Banks and Gesso, LLC

22 April 2003

RE: CEMEX, Inc Lyons Mine Permit No. M-1977-208 (SI-01)
Reclamation Cost for Demolition of the Cement Plant

Response to Comments

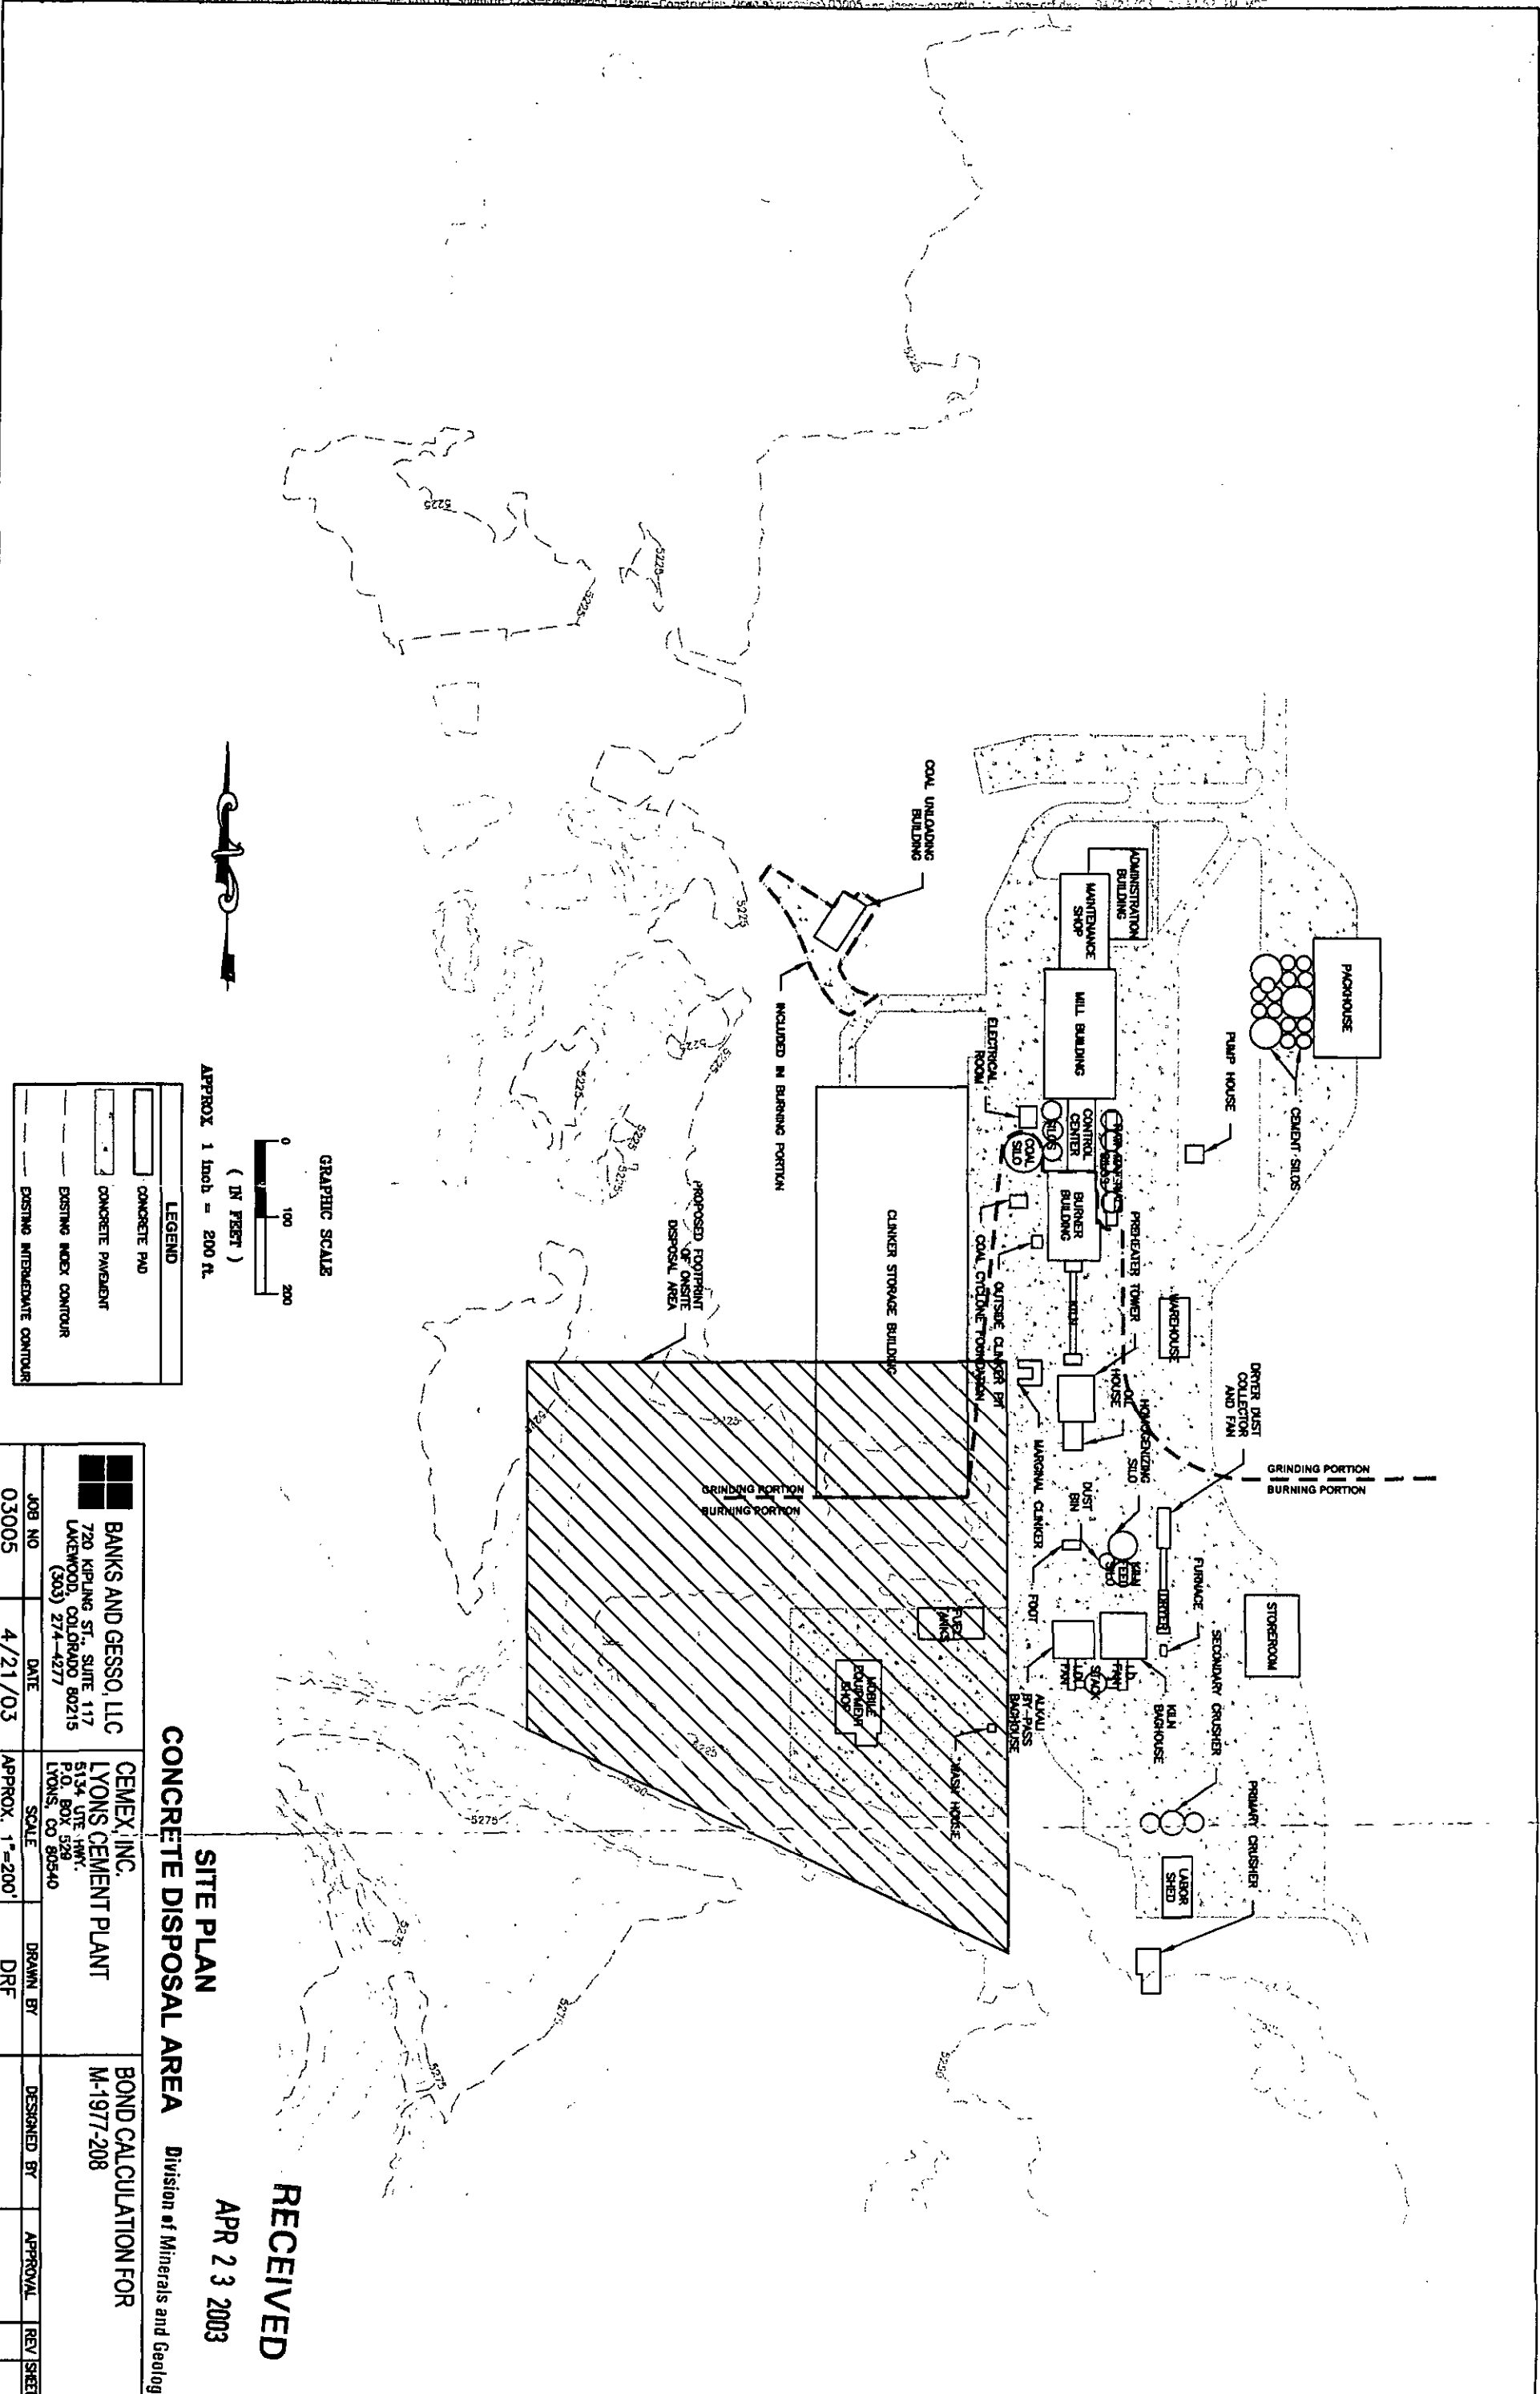
5. CEMEX provided a bond calculation map that is very helpful in determining the nature and location of structures at the cement plant. However, the map did not contain a scale necessary to determine the size of the structures. Please notify the Division as to the scale of the map, or provide a new map depicting a scale.

An approximate scale has been added to the schematic plan provided for this submittal. However, dimensions were taken from the engineering drawings, not scaled from a plan view map.

The site was divided into two areas for the estimate; the north part of the site is referred to as the Grinding portion, and the south part is referred to as the Burning portion. This division between the two processes allows a separate bond calculation in the event that the plant is modified so that only the Grinding process occurs in the future. The drawing included with this report depicts the division.

The selected disposal site is along a hogback ridge at the south end of the plant site (see site plan map). The disposal site will accommodate approximately 175,000 cubic yards of concrete. The disposal area will require only minor regrading to receive a geosynthetic liner with the appropriate permeability requirements. The disposal site will be capped with three feet of engineered fill, compacted per specifications and revegetated. The borrow source for the fill is located on the Cemex, Inc. Lyons Mine site, two miles or less from the location of the selected disposal site. Additional information on the disposal site including dimensions, the relationship to groundwater and surface water, and material placement techniques will be addressed in the Technical Revision.

Included with this submittal are the tables that summarize the quantities and the costs used for the work. Included as an appendix to this report is a set of more detailed calculation sheets that reference the drawings from which the dimensions of structures were taken. A plan view of the site indicating the process area delineation and labels of structures is also attached.
